ADDENDUM NO. 1

MARKET STREET IMPROVEMENTS and FIFTH STREET ACTIVE TRANSPORTATION STP-5507(607) & TAP-5445(613)

COUNTY OF JEFFERSON, MISSOURI

April 3, 2026

XS SHEET
 SHEET 18 OF 20
 KIMMSWICK GREAT
 STREETS PHASE I

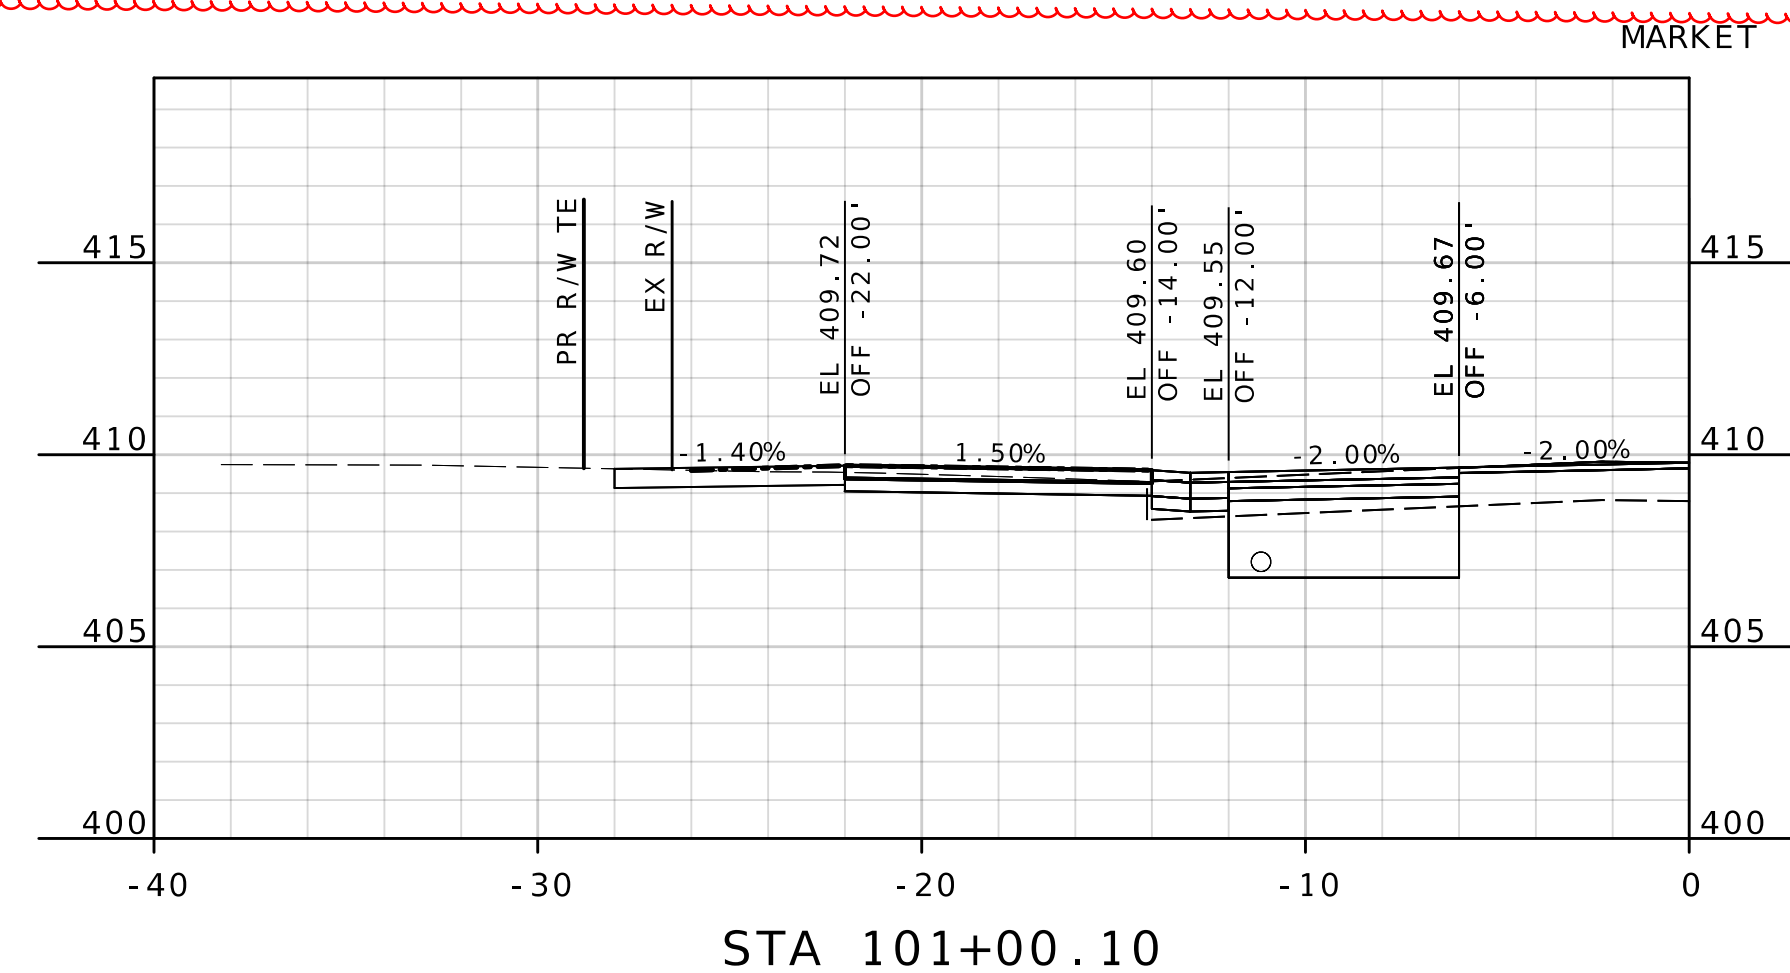
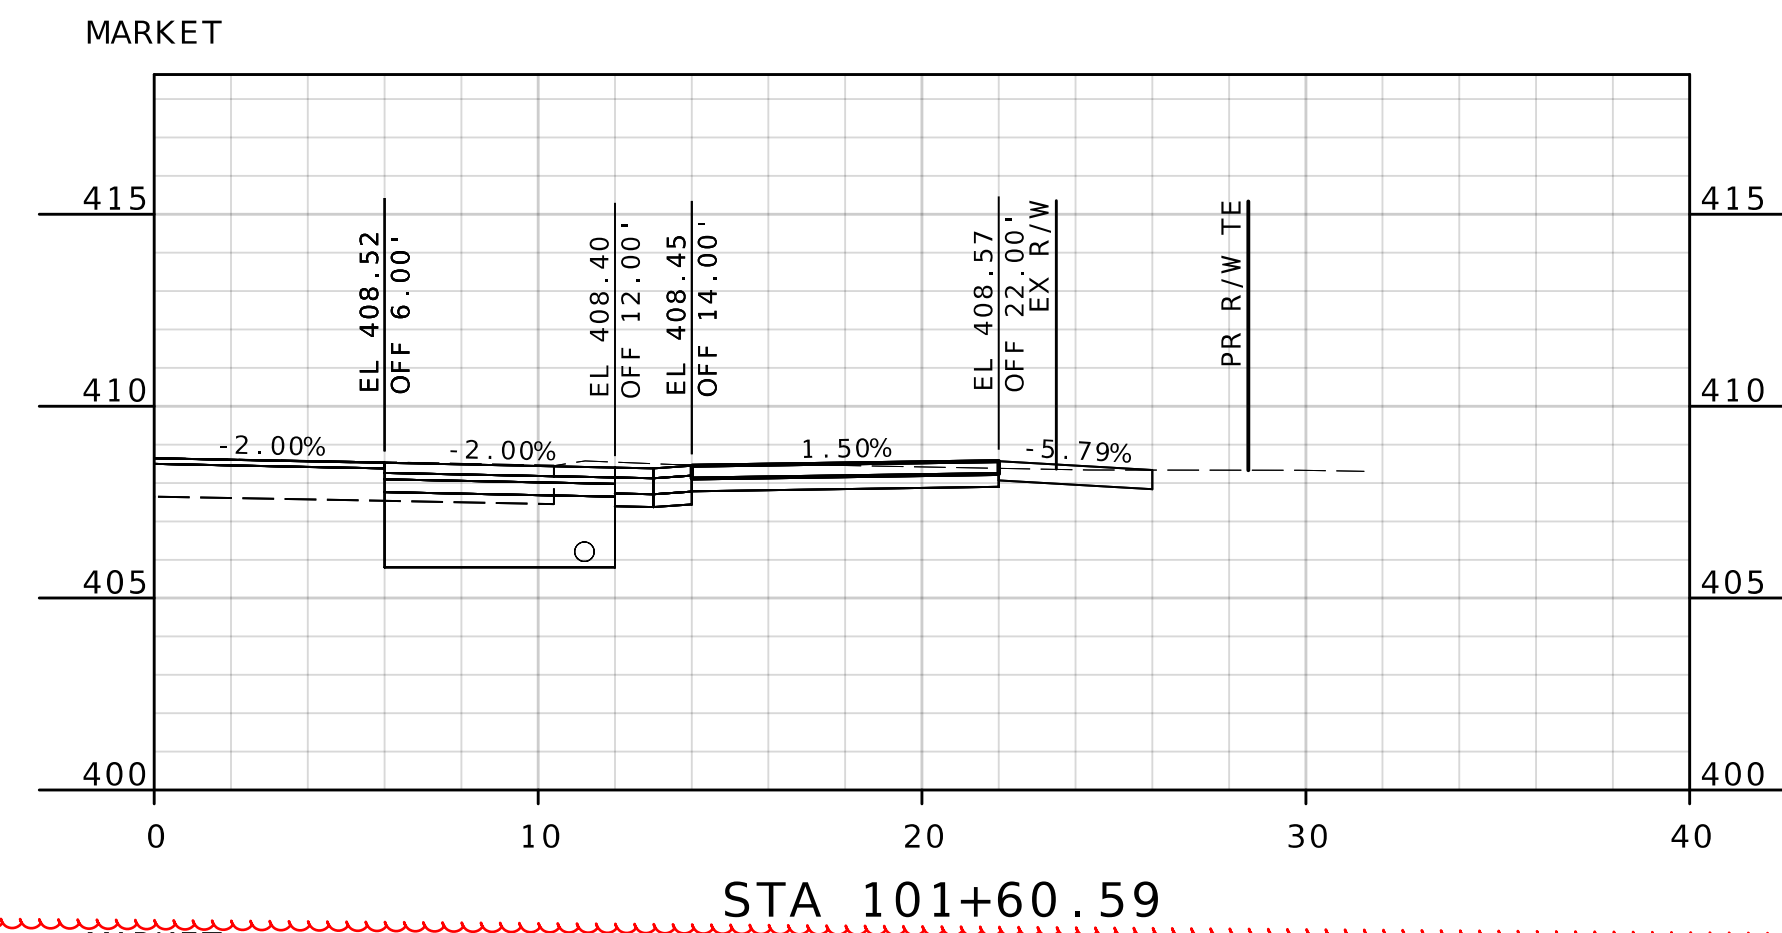
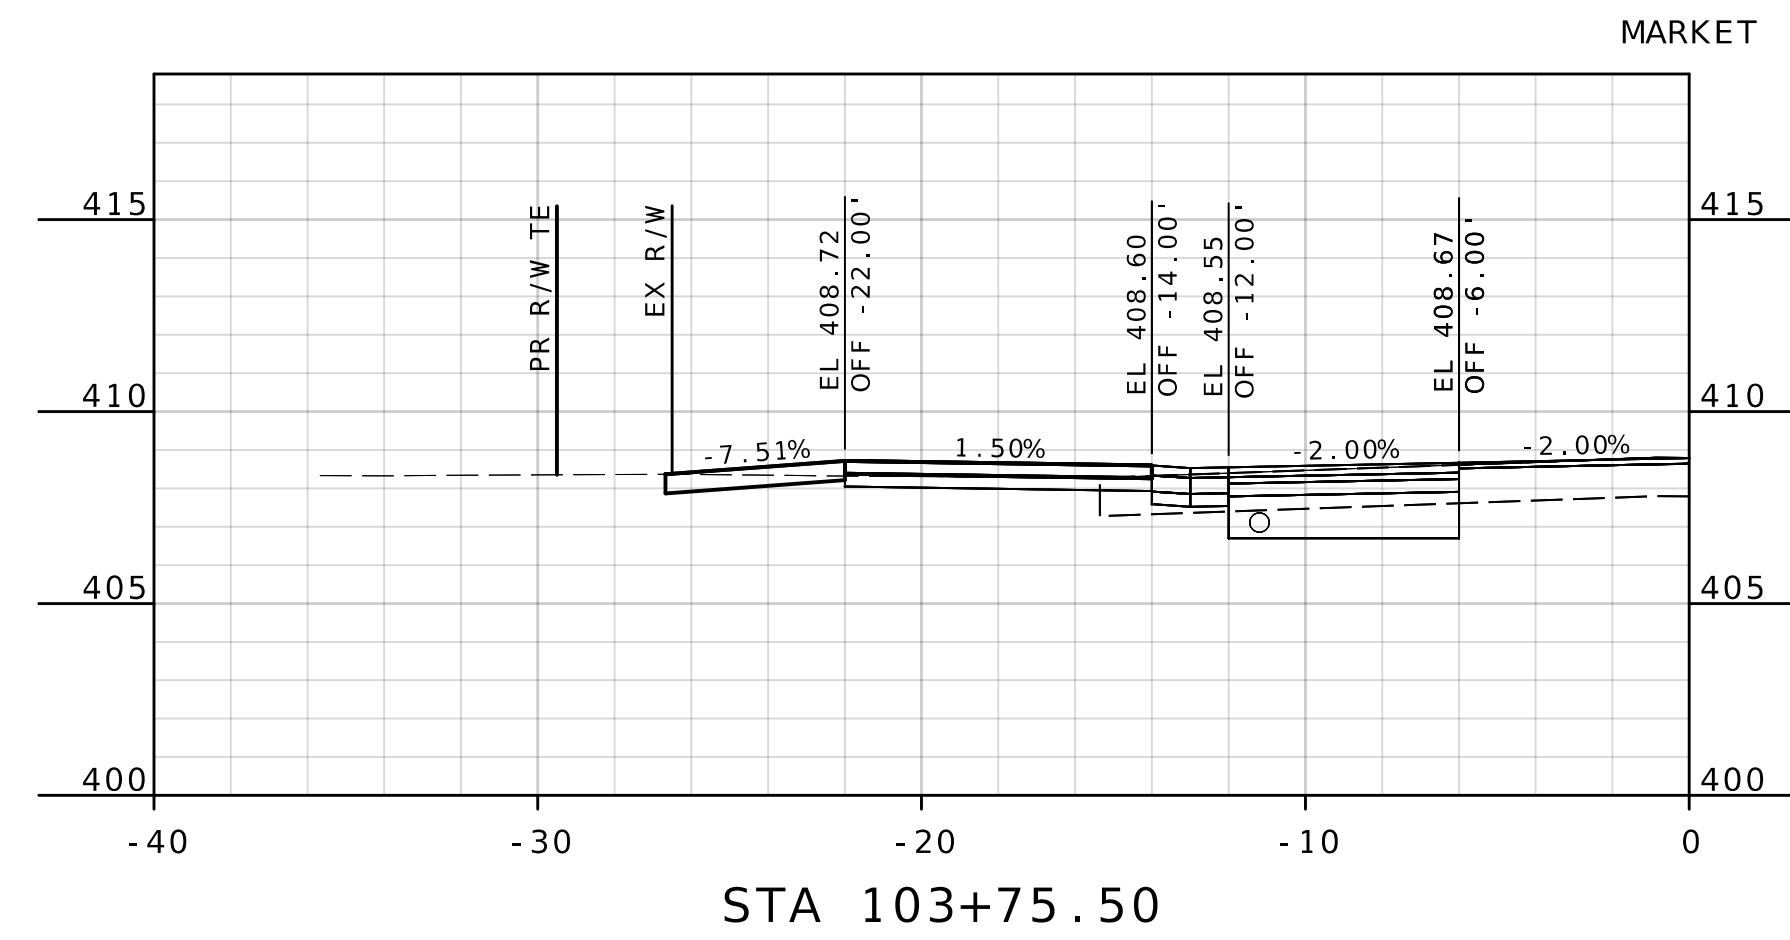
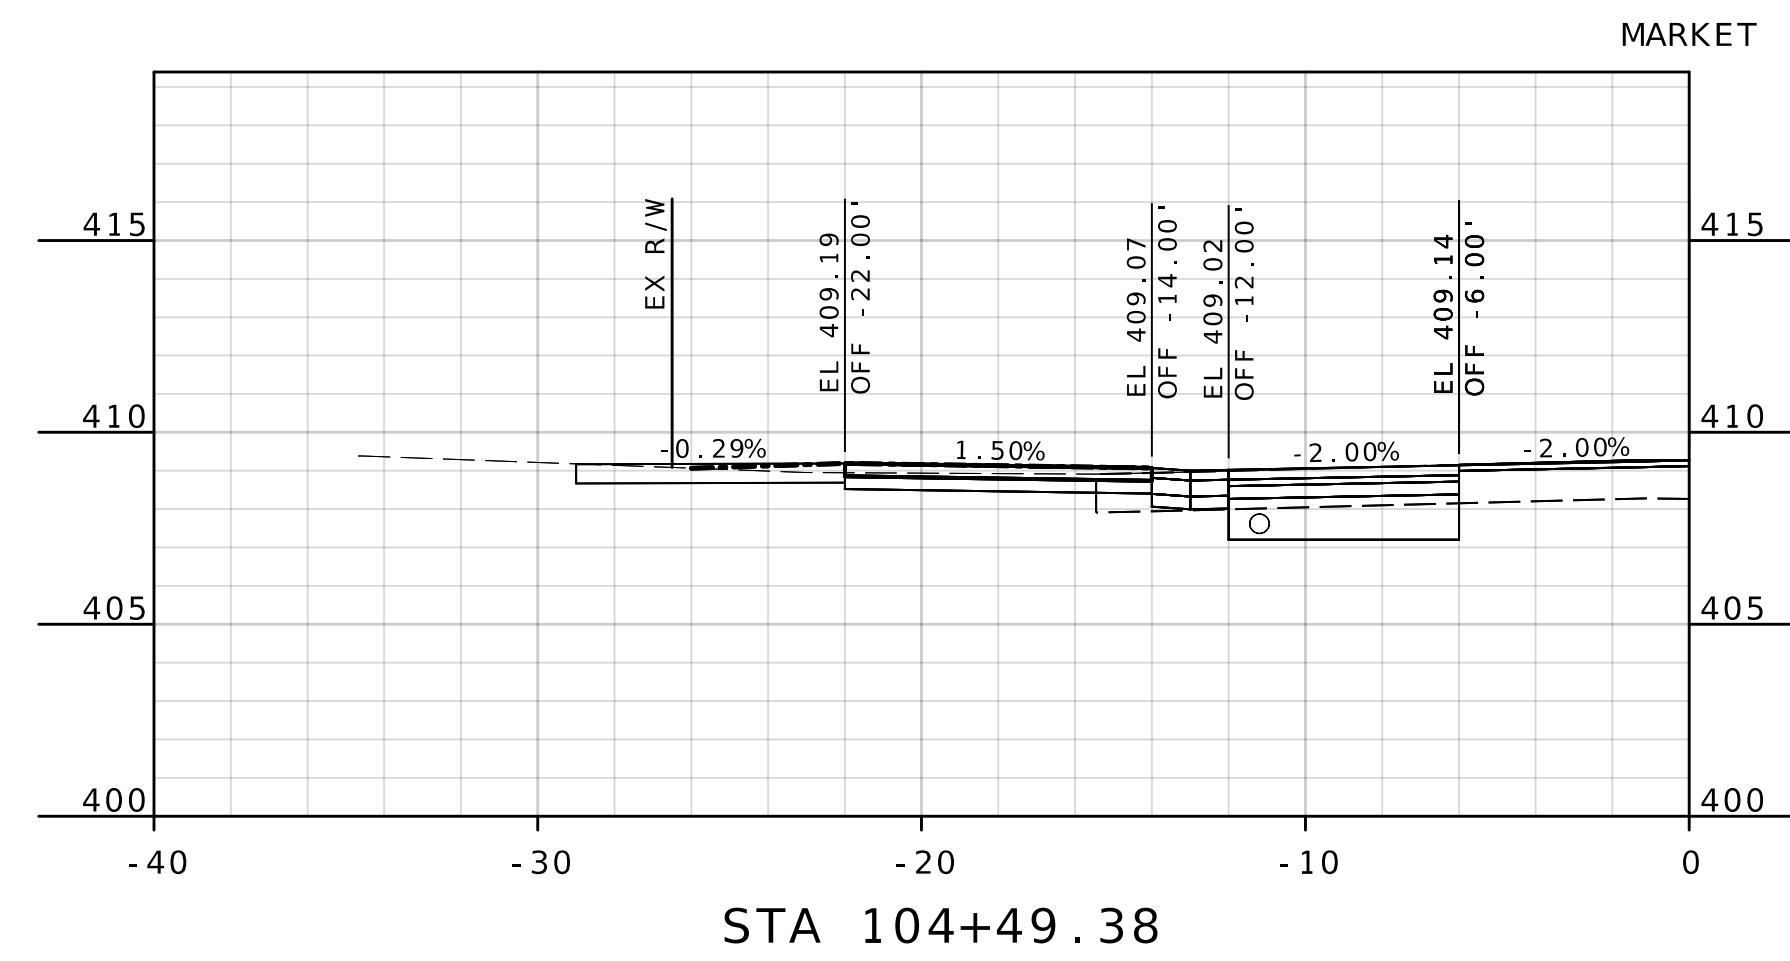
XS Sheet 18 of 20 and XS Sheet 19 of 20 have revisions to the cross sections.
